July 11, 2024

RE: Stride S3 Line Project

Under the circumstances, after a detailed analysis of ST data and documents and in consultation with our community, we are now formally proposing the following alternative design concept for BAT transit improvement through Lake Forest Park (see attached).

DRAWING No.:
BT322-CMP207
 FACILITY ID:
BT322
 SHEET No.:
0735
 REV:

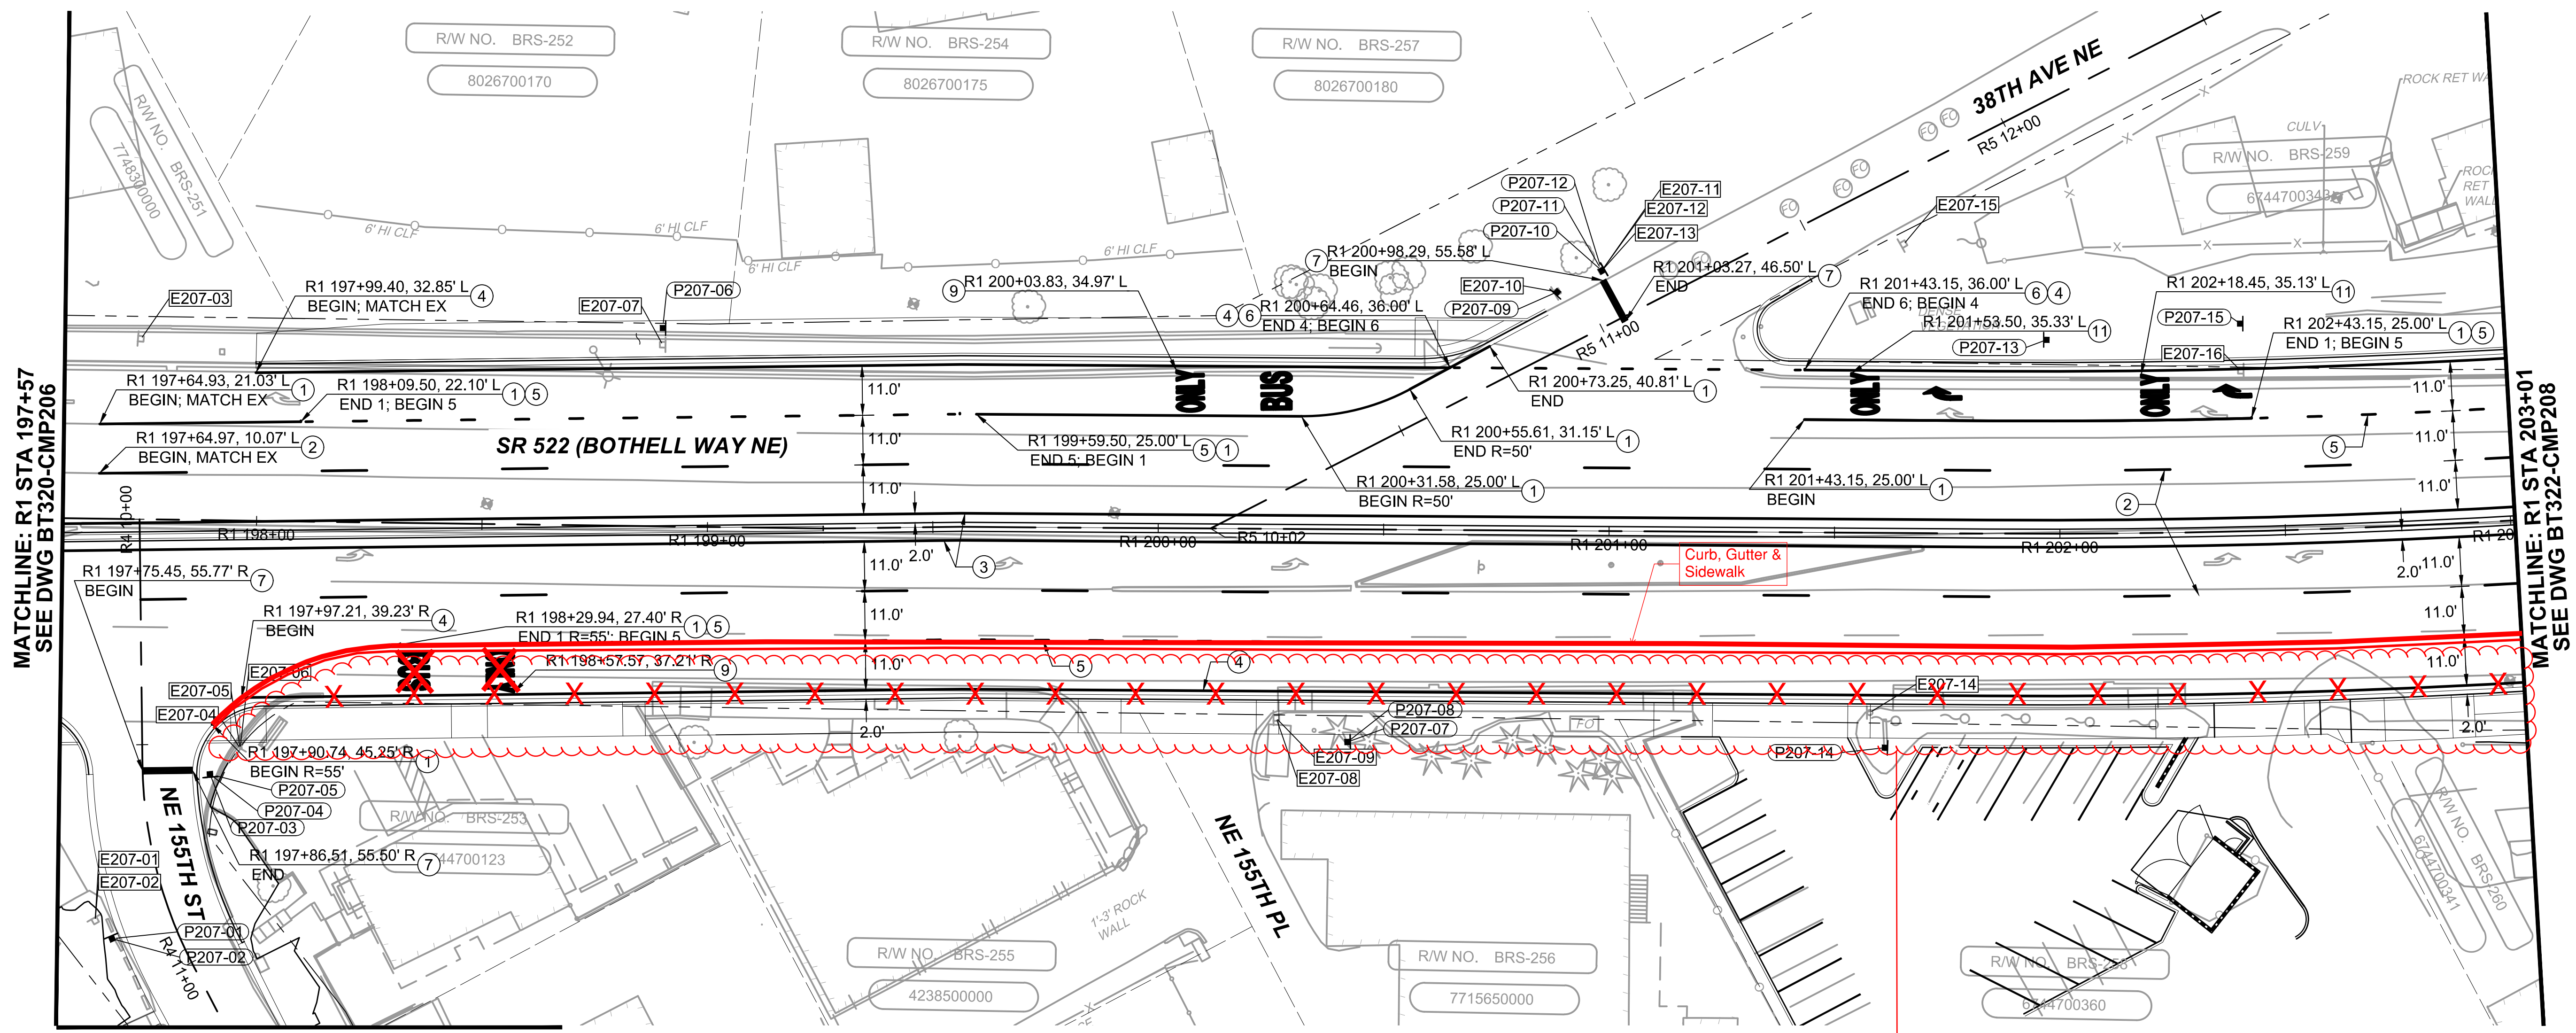
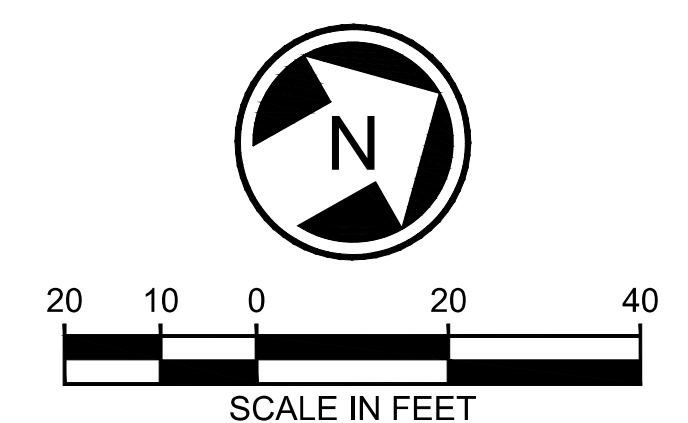
Shift sidewalk, curb, and edge of pavement improvements to align with proposed edge of thru lane.

Suggested Modifications
 1. Revise roadway, curb, and sidewalk geometry to remove BAT lane to reduce ROW impacts and preserve mature vegetation as much as feasible.

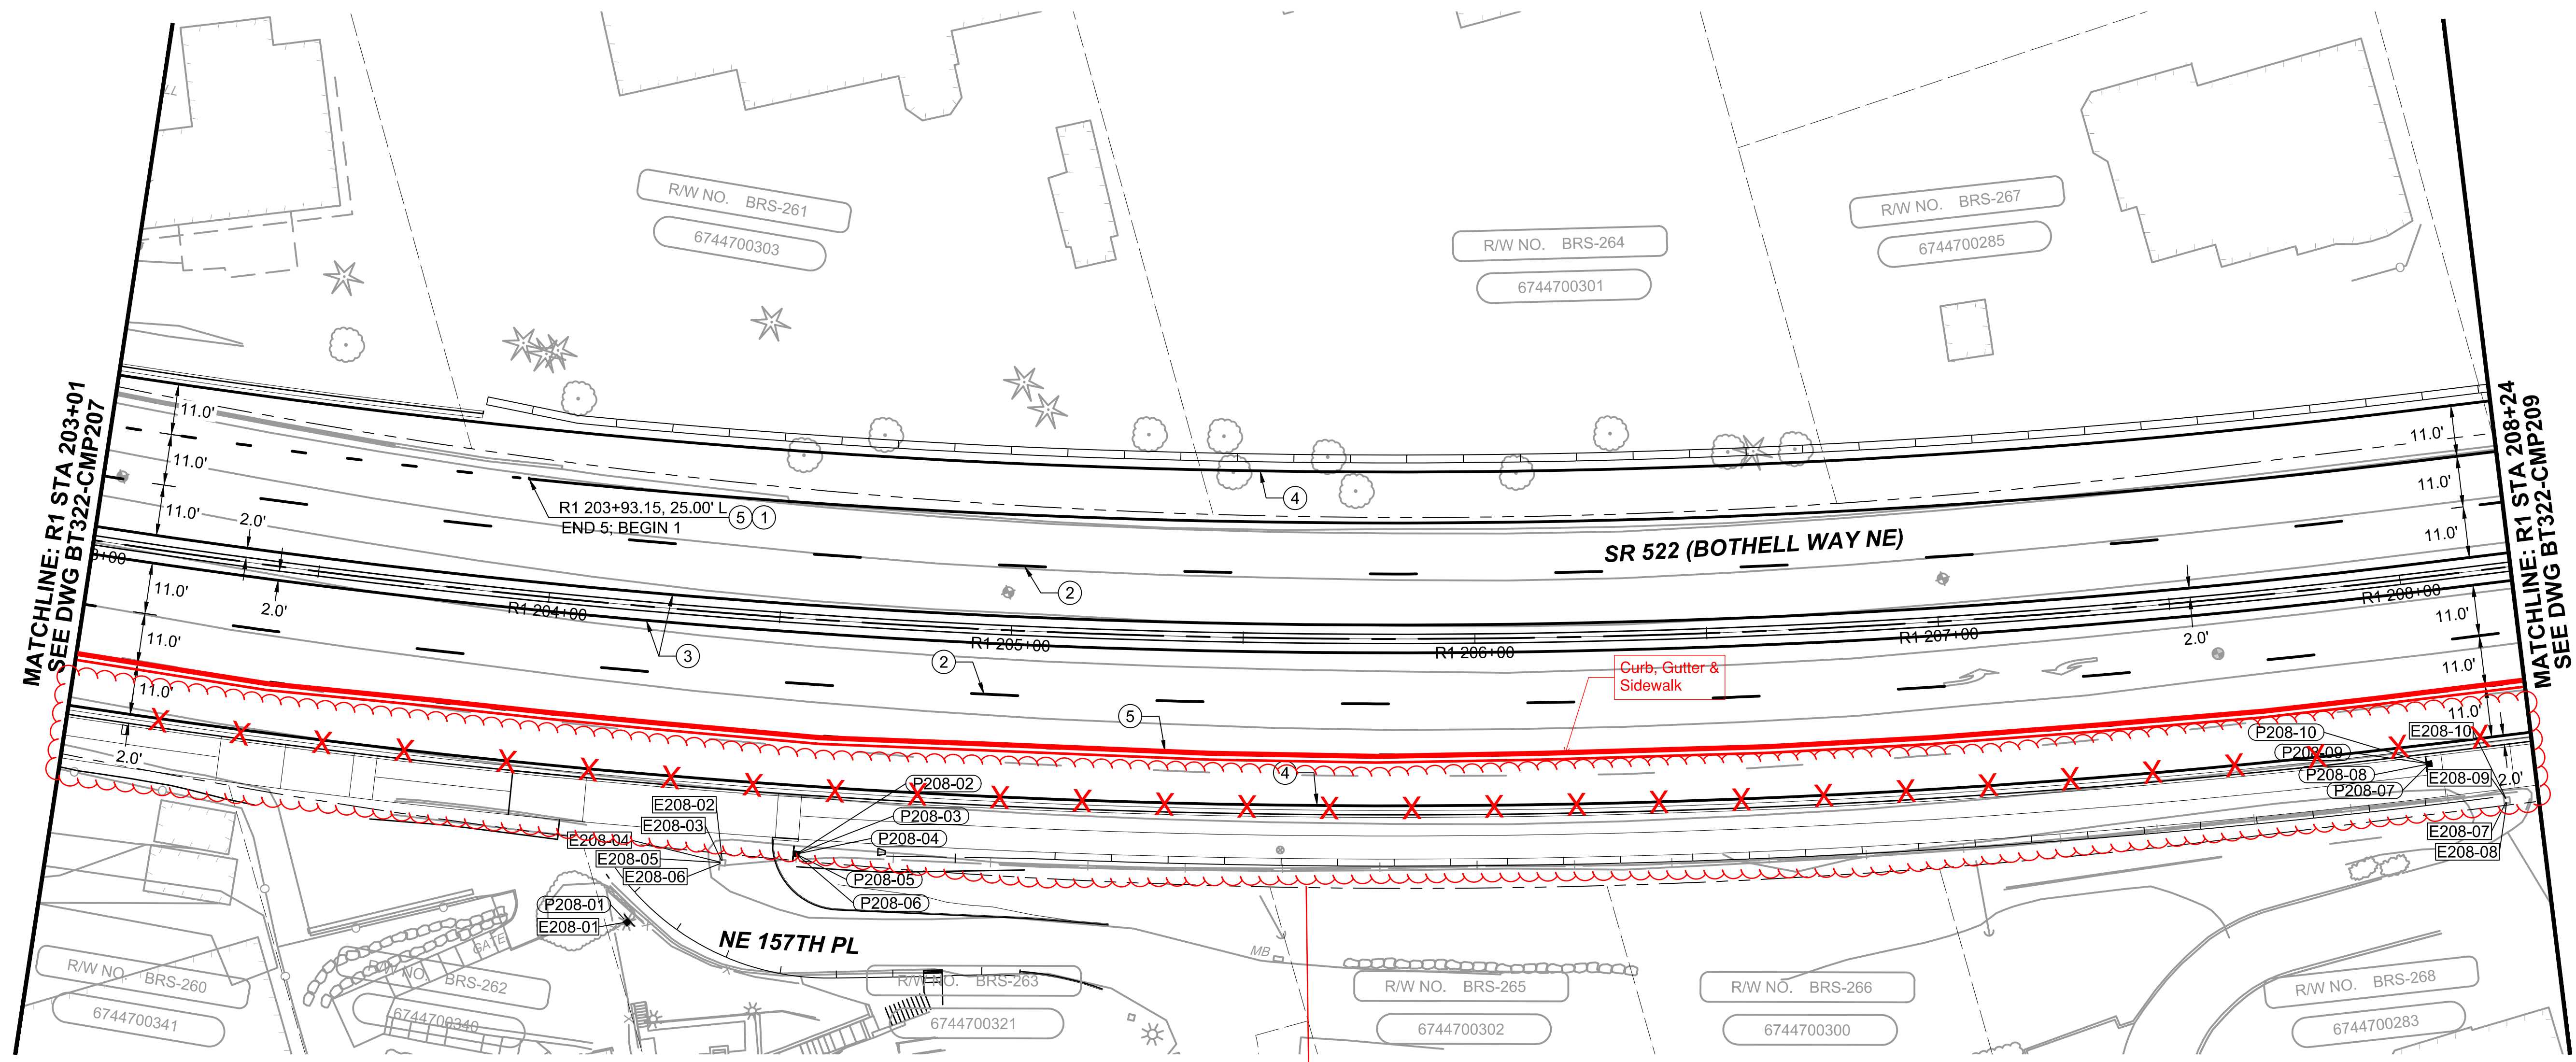
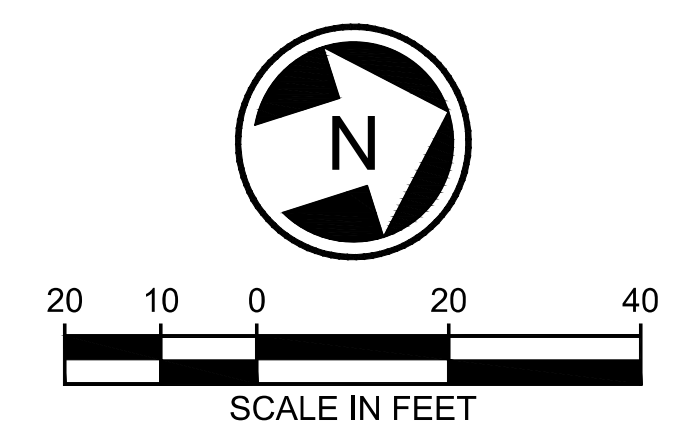
Shift sidewalk, curb, and edge of pavement improvements up to more closely align with existing roadway limits.

Suggested Modifications
 1. Revise roadway, curb, and sidewalk geometry to remove BAT lane to reduce ROW impacts and preserve mature vegetation as much as feasible.

DRAWING No.:
BT322-CMP209
 FACILITY ID:
BT322
 SHEET No.:
0737
 REV:

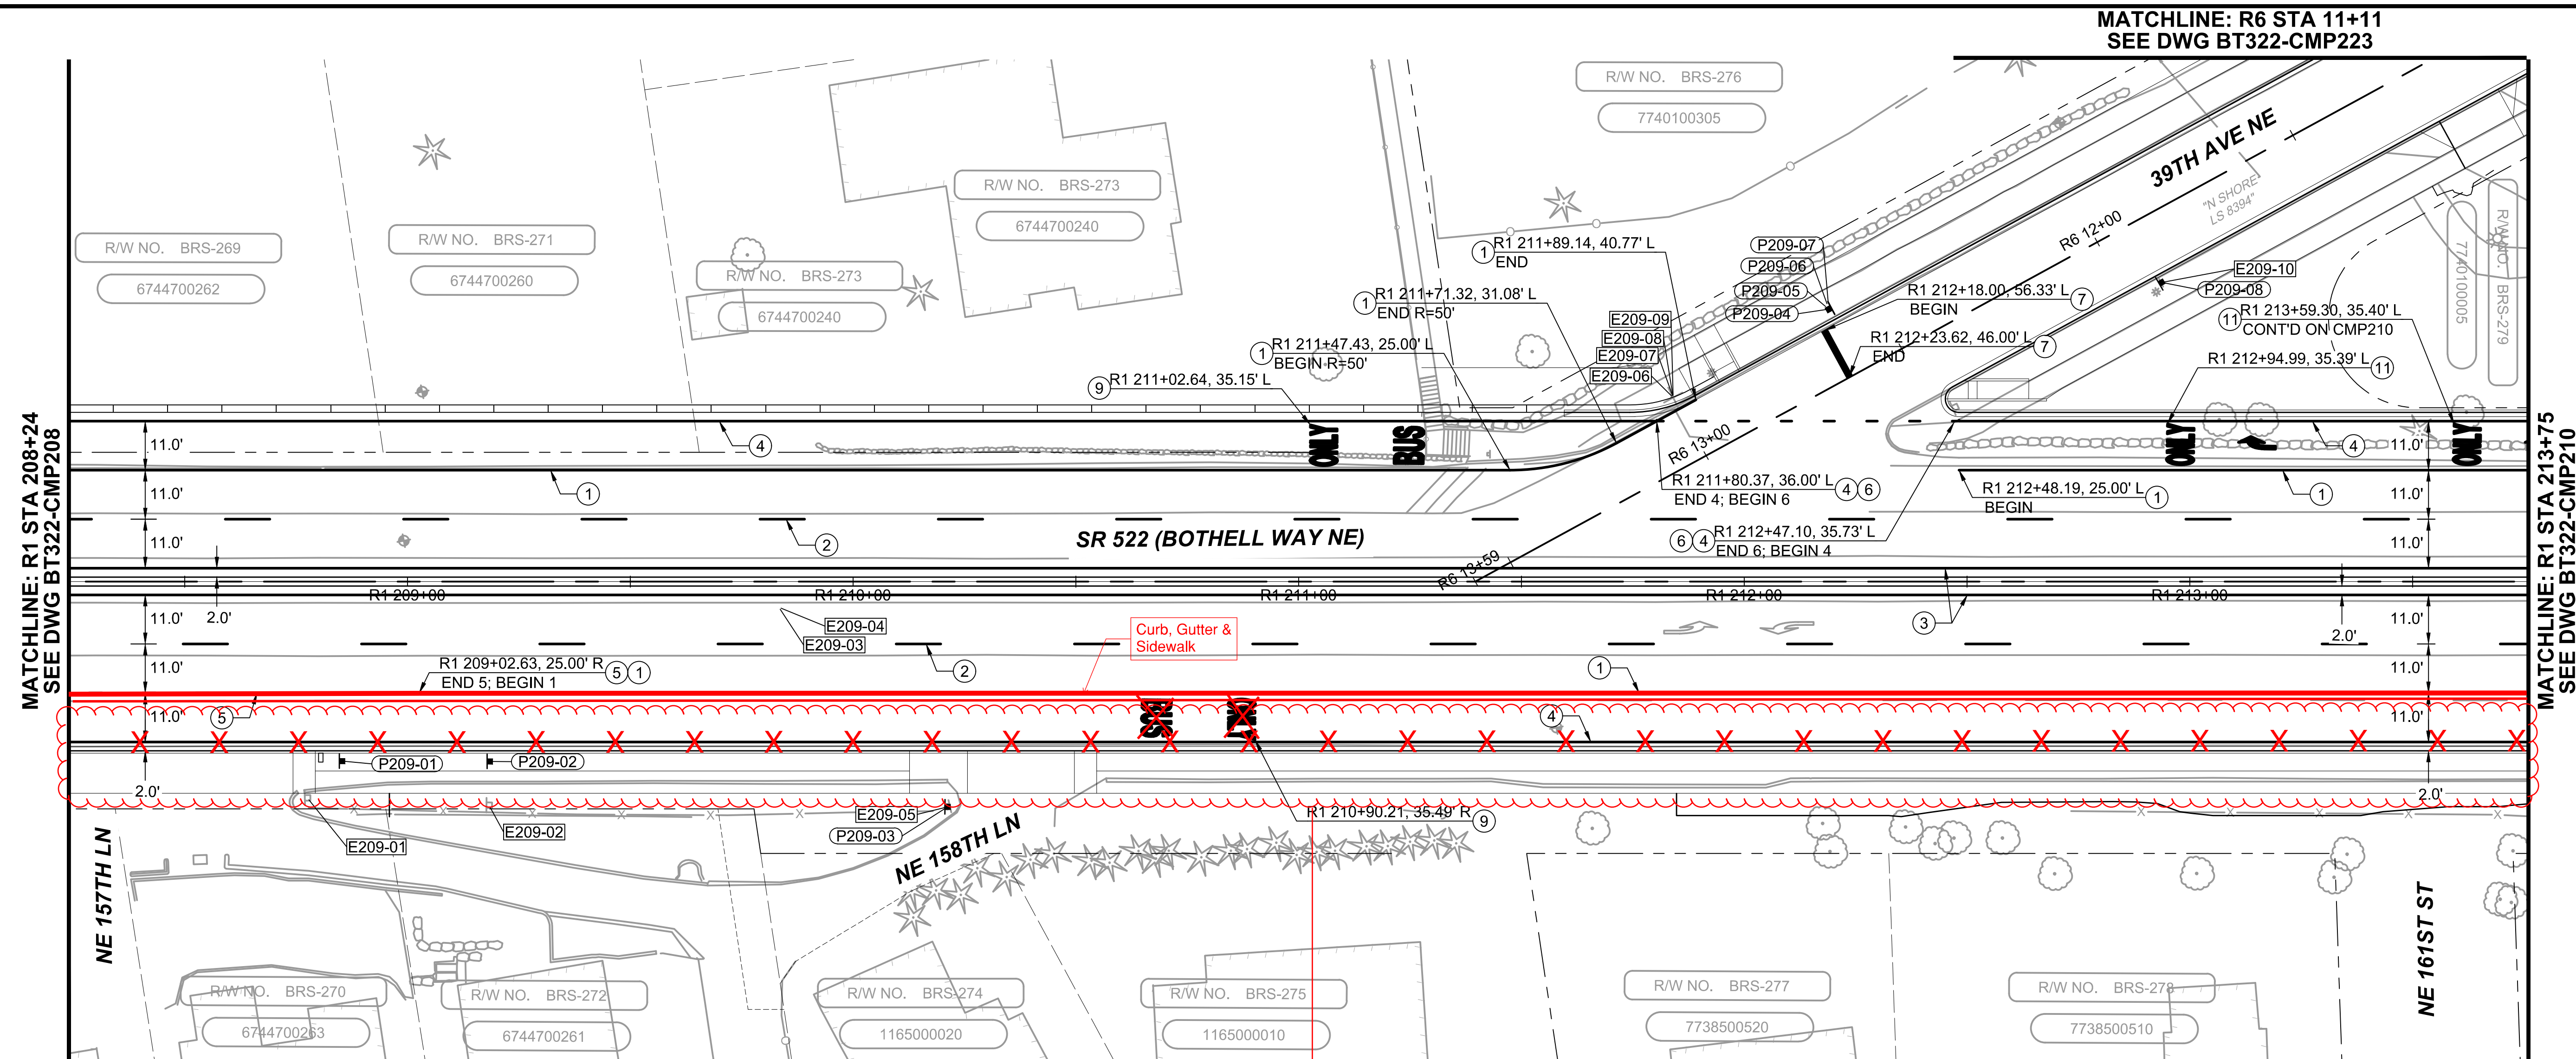
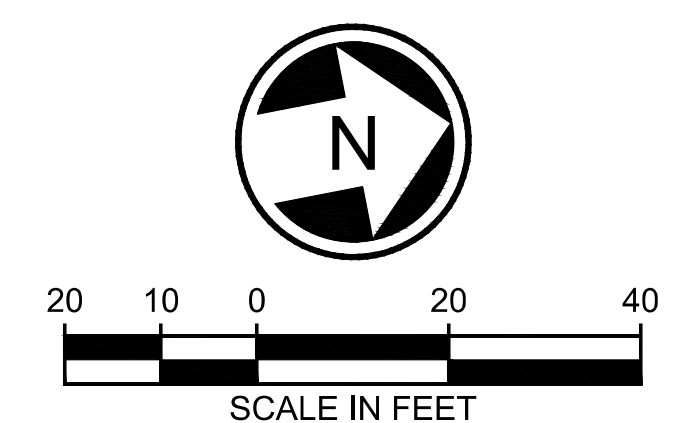
Shift sidewalk, curb, and edge of pavement improvements up to more closely align with existing roadway limits.

Suggested Modifications
 1. Revise roadway, curb, and sidewalk geometry to remove BAT lane to reduce ROW impacts and preserve mature vegetation as much as feasible.
